WOLF CREEK

Subject: Docket No. 50-482: Changes to Wolf Creek Generating Station
(WCGS) Radiological Emergency Response Plan, Implementing
Procedures and Form

Enclosed are revisions to WCGS Radiological Emergency Response Plan (RERP), implementing procedures and a form. The RERP revision reflects those changes which ensure that the plan contains the information necessary to satisfy the program content requirements of 10 CFR 50, Appendix E and 10 CFR 50.54(q). These revisions were discussed with NRC staff during the August 30-September 3, 1999, inspection. The implementing procedures and associated form contain supplemental changes to update the titles of Shift Manager and Control Room Supervisor.

Radiological Emergency Response Plan Change Summary

FIGURE 3
TSC/OSC ORGANIZATION

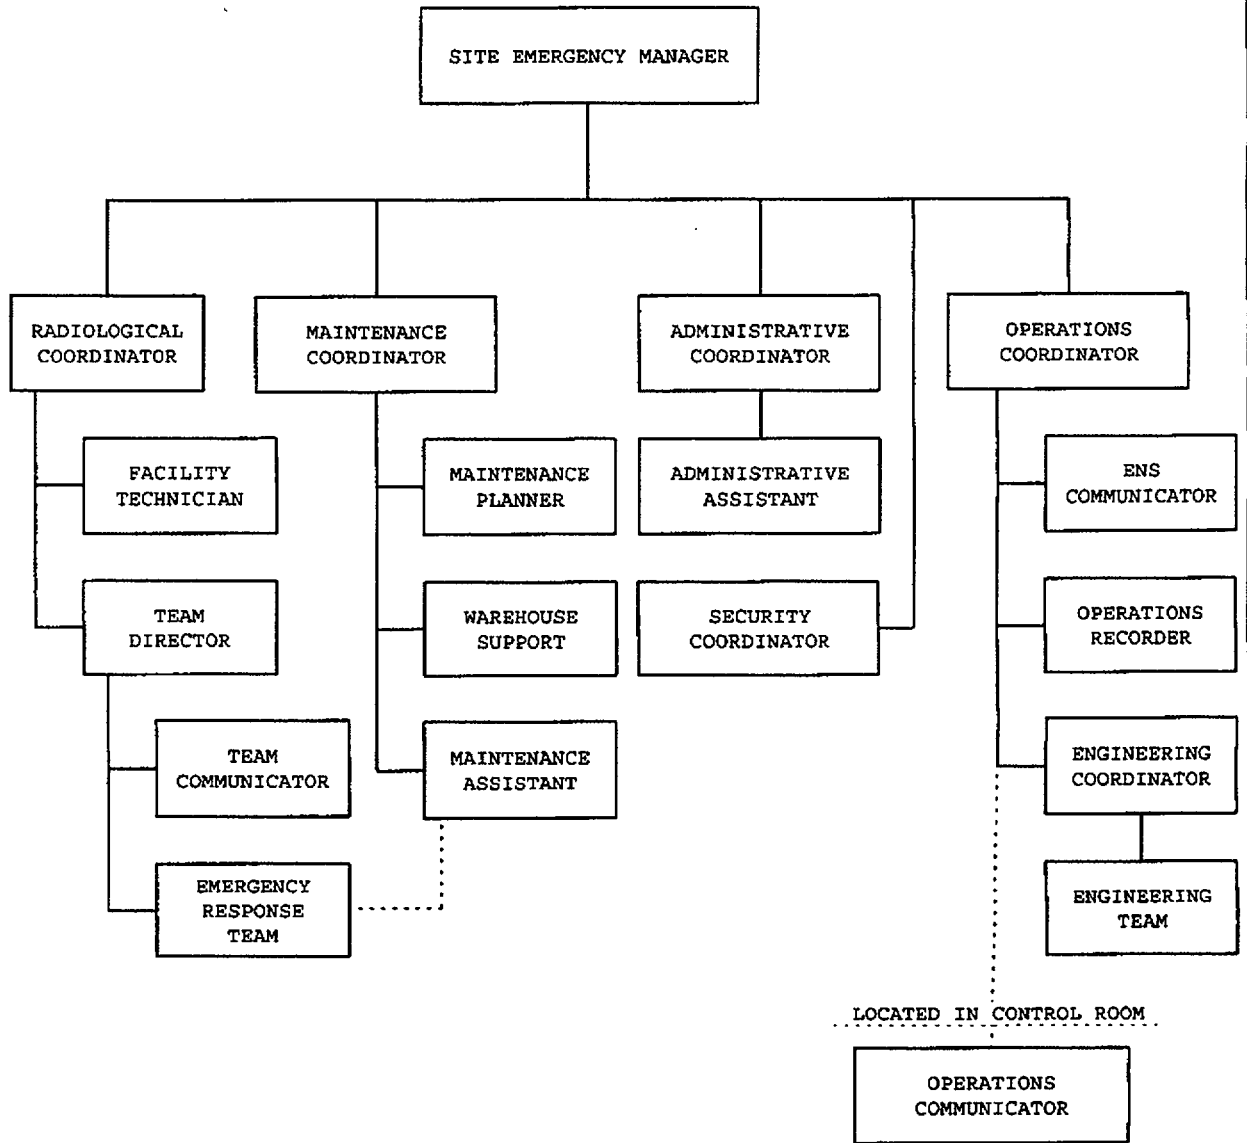
| RERP STEP # | DESCRIPTION OF CHANGE |
|--------------|--|
| Figure 3 | Added "Security Coordinator" to Organization chart. |
